## ATTACHMENT 2

## DETAILED ASSESSMENT

The site of this Planning Proposal comprises 815 Pacific Highway and 15 Help Street, Chatswood, being Lot 1 in DP 547585 and Lot1 in DP 731307, and is located within the Chatswood CBD.

Figure 1 – CBD Boundary

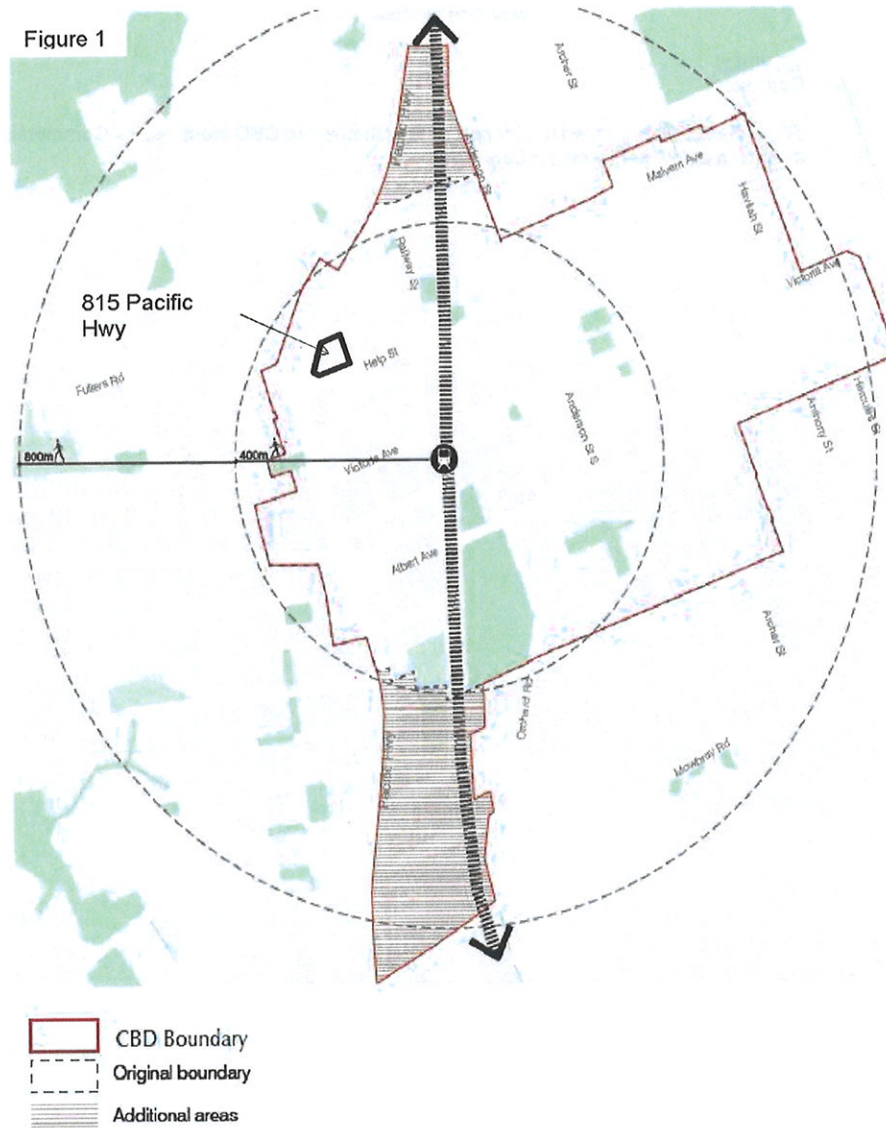
The subject site is located within the expanded Chatswood CBD boundary defined in the *Chatswood CBD Planning and Urban Design Strategy*, as shown below in Figure 1 – CBD Boundary.

Figure 2 – Land use

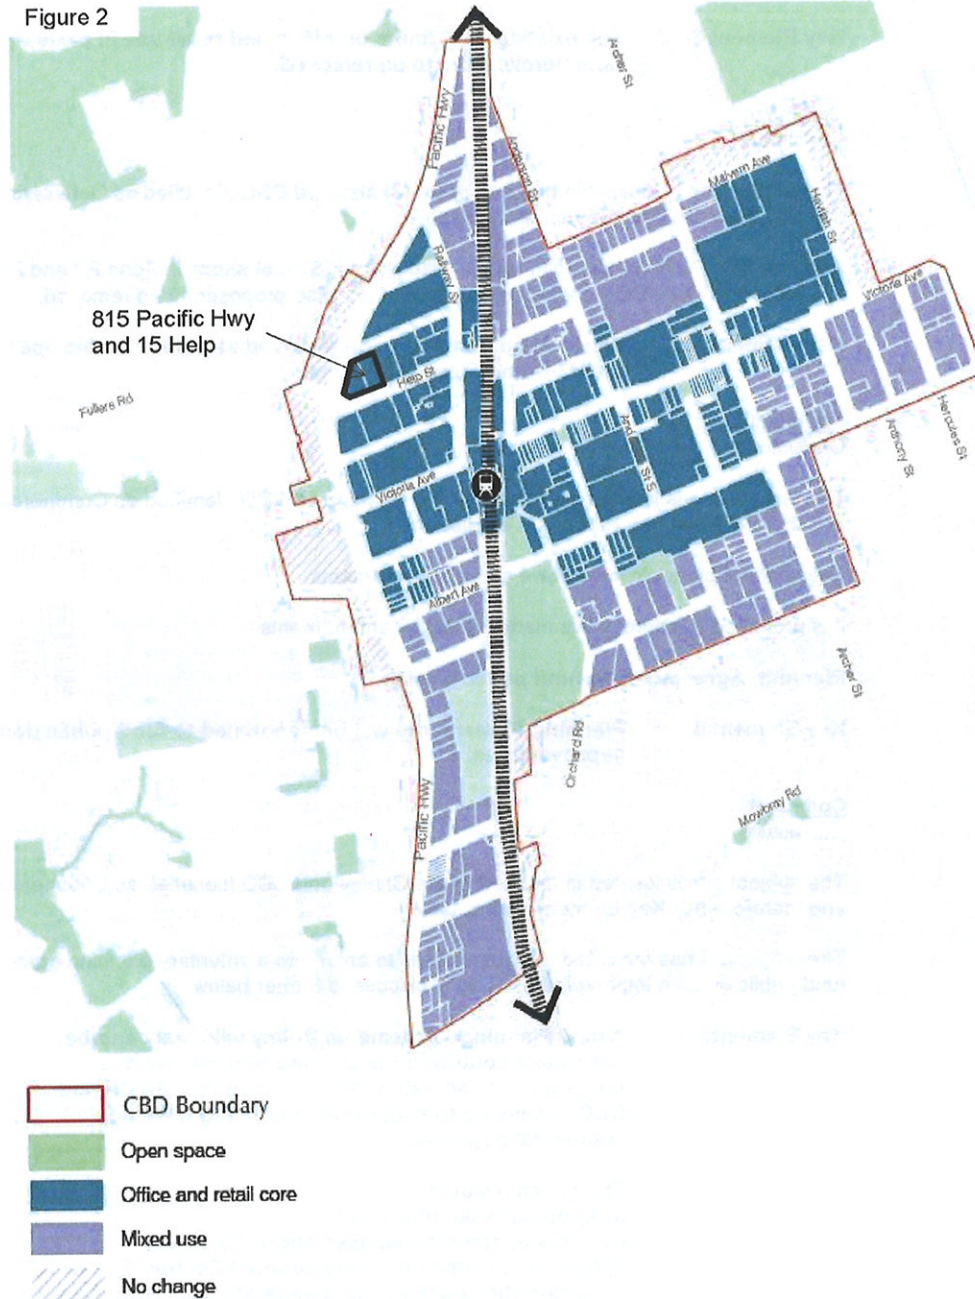
The subject site is located in that part of the Chatswood CBD identified as Commercial Core, and the Planning Proposal involves a proposed commercial floor space ratio of 17.2:1.

Figure 8 – Setbacks and street frontage heights

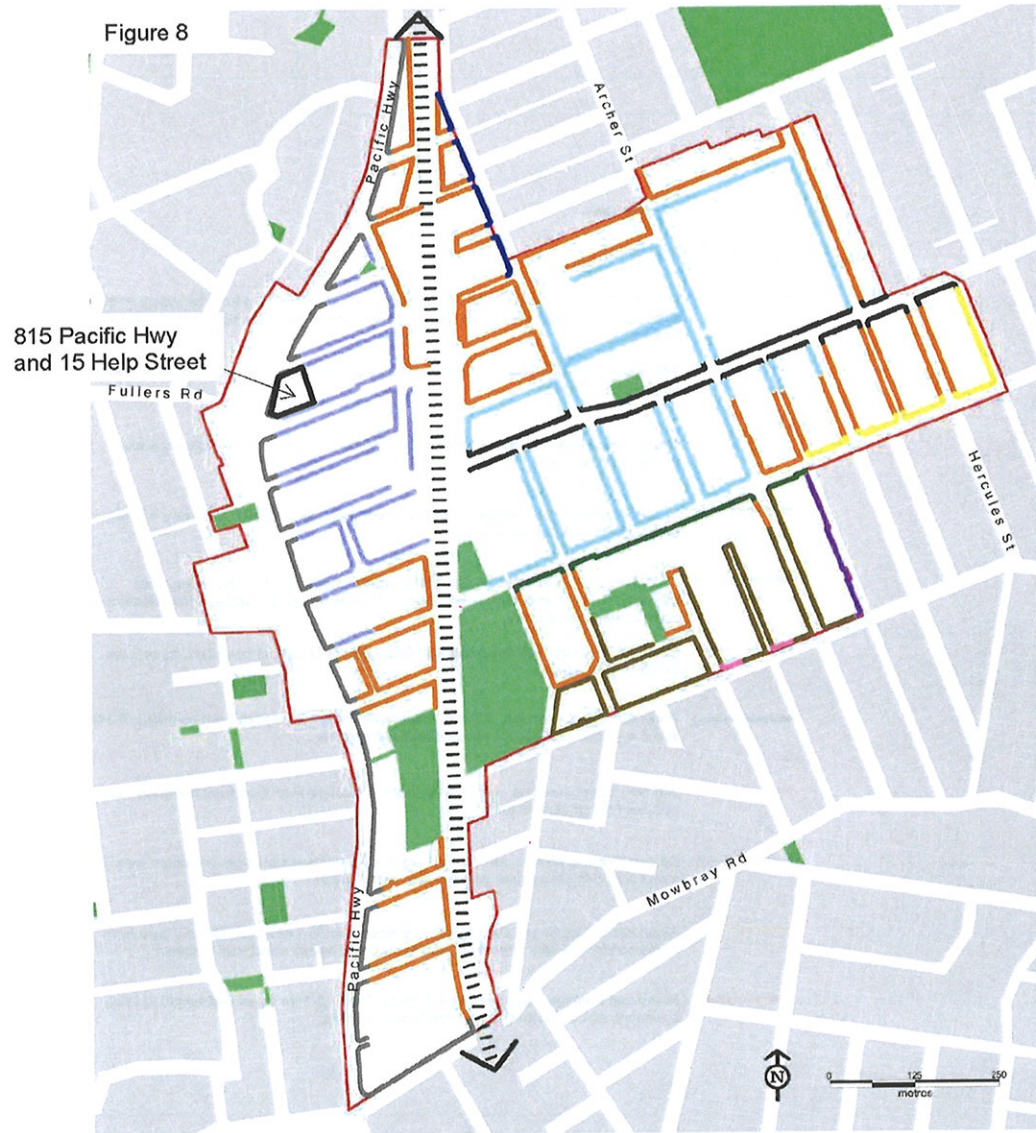
The concept plans are consistent with the above Figure 8 requirements applying to the subject site.

These requirements have also been included in the proposed draft *Development Control Plan* provisions and in the Concept Plans.
